S3 DISTRIBUTOR - TRAPPED L.T. LEAD

CATEGORY 3SPEEDOMETER DRIVE CABLESDESCRIPTION

S3 STARTER MOTORSAPPLICABLE TO :

DIRECTION INDICATOR SWITCHAPPLICABLE TO:

Fig.1 Dimensions - Distance piece

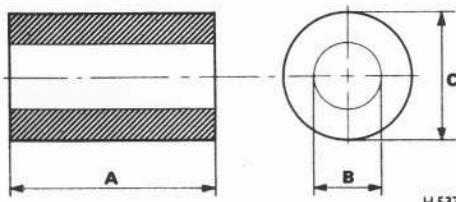
In order to fit a Kienzle clock in place of the Smith's unit, it is necessary to fit two distance pieces between the clock mounting lugs and the instrument board, and to fit a different type of terminal to the clock feed cable.

The distance pieces cannot be obtained from Rolls-Royce Limited but are readily manufactured from a short length of $\frac{3}{8}$ in. (9,53 mm.) diameter bar to the dimensions given in Figure 1. The Lucar terminal and sleeve required are standard items which should be readily obtainable. Two 3 B.A. screws, 1 in. (2,54 cm.) in length, are also required.

It is imperative that a good electrical connection is achieved between the clock casing and the instrument board, therefore, the contact faces of the distance pieces should not be painted.

4. Cut the flag terminal from the end of the purple feed cable; in its place fit a 17½ amp. Lucar terminal and sleeve.
5. Connect the purple feed cable to the insulated terminal at the rear of the Kienzle clock. Fit the instrument lamp to its holder.
6. Fit the Kienzle clock to the instrument board using the two distance pieces and two 3 B.A. screws 1 in. (2.54 cm.) in length.
7. Fit the facia panel.
8. Connect the battery.

Distance pieces - Brass or aluminium (to give good earthing points)	2 off
Lucar terminal and sleeve	1 off each
3 B.A. screws 1 in. (2.54 cm.) long	2 off

Figure 1. Direction indicator switch (UR 16530)

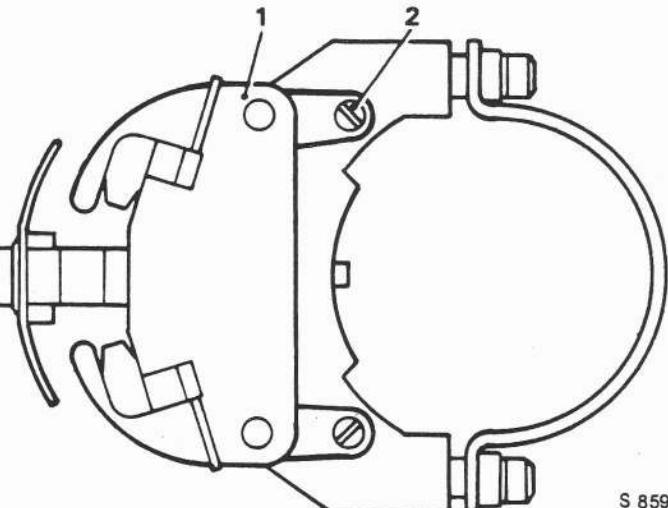
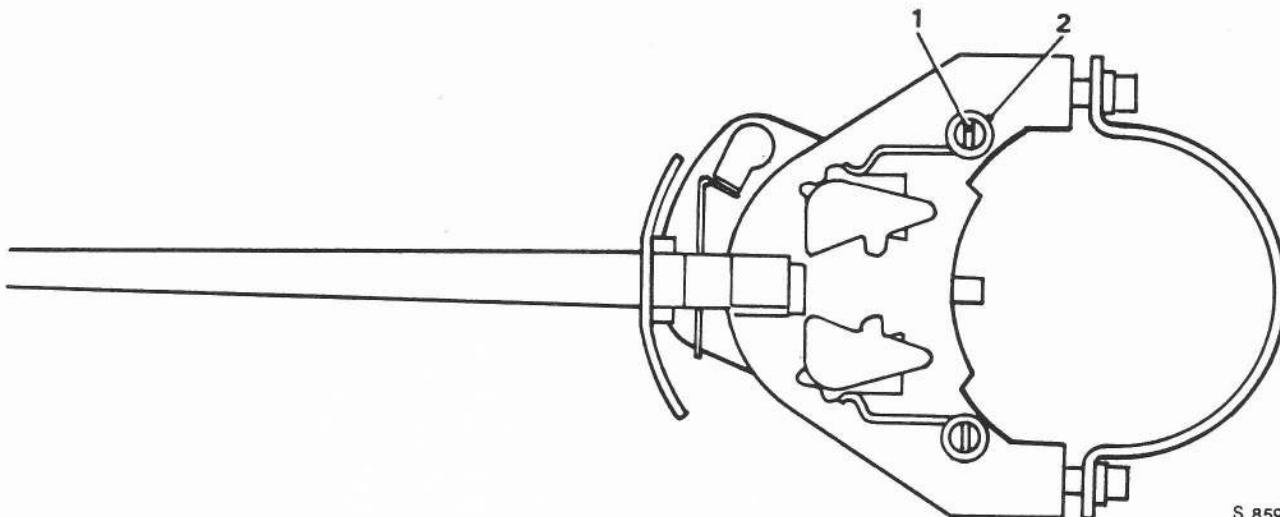
The direction indicator switch UR 5273 is no longer available. For replacement purposes, the switch used on Silver Shadow cars (UR 16530) will be fitted. When it is fitted, the terminal connectors must be changed.

1. The removal and replacement procedure for the new switch remains the same as for the old. However, there is a small modification to be carried out on the new switch as follows:
2. Remove the two screws and discard the brown insulation board (see Fig. 1). Replace the screws with a washer (X 4401) behind each screw head (see Fig 2).
3. Cut the 7 pin plug off and withdraw the insulation board along with the green/yellow and green/blue wires.
4. Fit 'Lucar' connectors to all the wires except the black one to which a bullet connector is fixed. Connect the wires as follows.
